## ORIGINATION FORM

Proposed Revisions to a Standard Plans Index  
(Please provide all information — Incomplete forms will be returned)

Index Number: 430-022  
Sheet Number (s): 7  
Index Title: Side Drain Mitered End Section

LAST REVISION 11/01/20	DESCRIPTION:	FDOT FY 2021-22 STANDARD PLANS	SIDE DRAIN MITERED END SECTION	INDEX 430-022	SHEET 7 of 7
---------------------------	--------------	--------------------------------------	--------------------------------	------------------	-----------------

**FASTENER UNIT AND GRATE DETAILS**

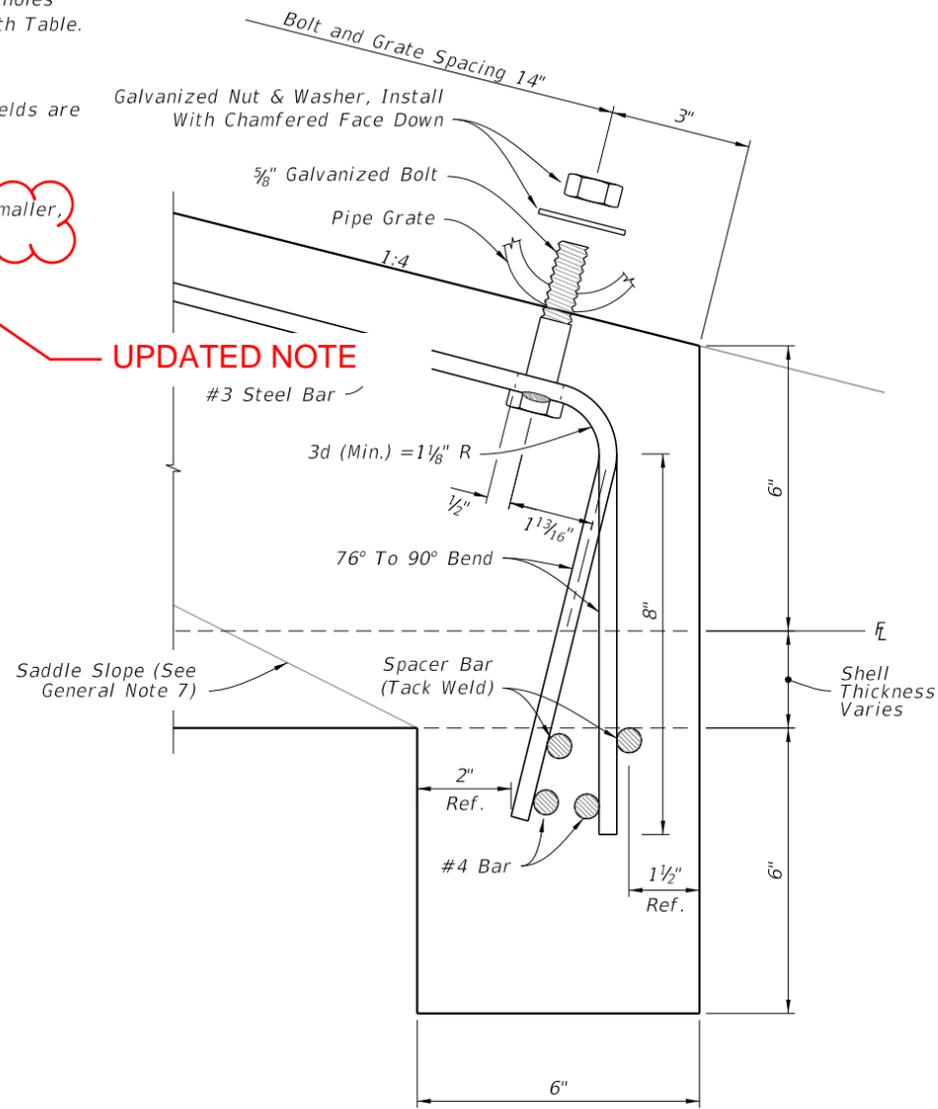
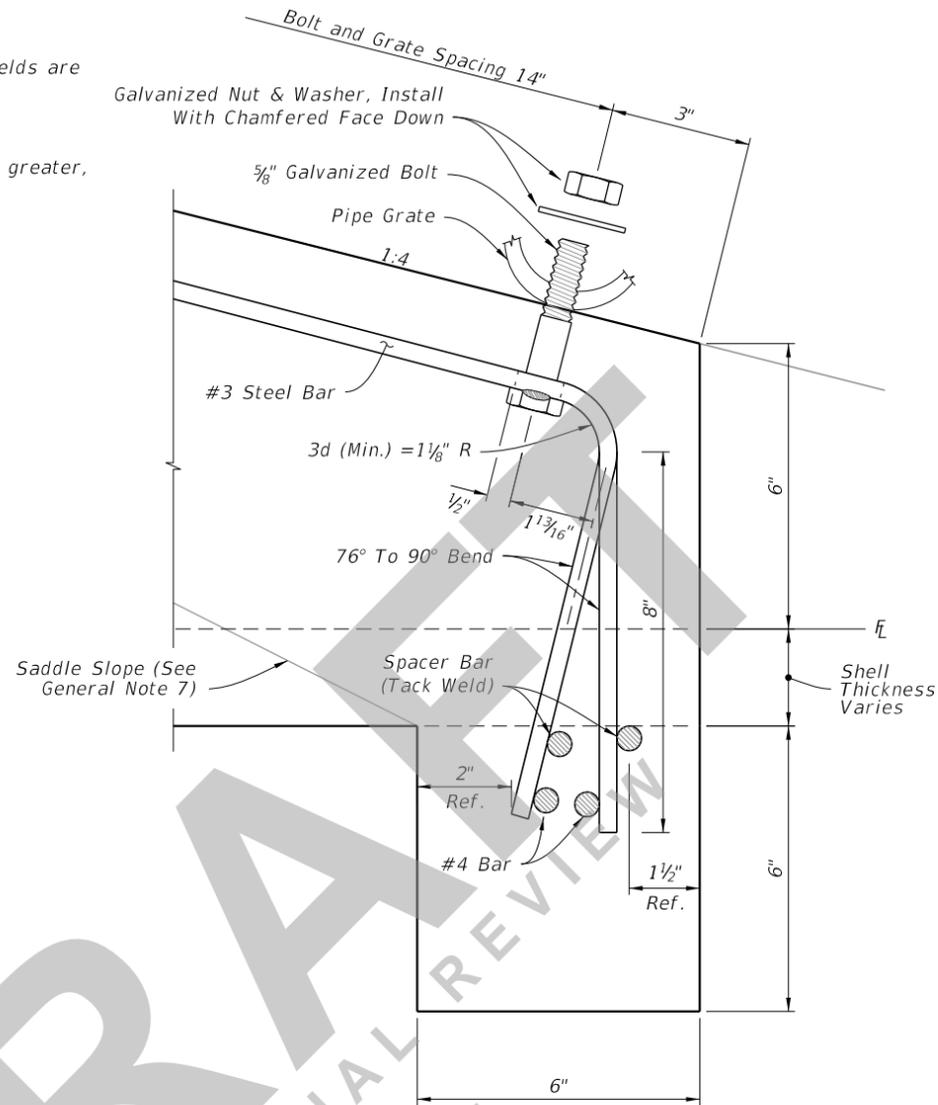
Sheet 7: Updated Note 5.

It was brought to our attention that the note could be confusing. Reworded to make it clear that all larger pipes require grates.

**UPDATED NOTE**

- 5/8" x 3" bolts are standard for all grate fasteners, except when the contractor elects to use the slotted upper holes for the intermediate fasteners on multiple drain pipes, which will require bolt lengths in the Special Bolt Length Table.
- 5/8" galvanized bolt hex head bolt shown; either hex head or square head bolt may be used. Use only hex nuts.
- Make the specified weld when the fabricated unit is subject to hazardous hauls and repeated handling. Tack welds are permitted for local or job site fabrication. Galvanizing over welded surface not required.
- Omit on trailing downstream ends on divided roadways.
- Use grates on all round pipes 30" or greater, Pipe arches 35" x 24" or greater, and elliptical pipe 19" x 30" or greater, unless excluded in the Plans. Use grates on smaller pipes only when called for in the Plans.
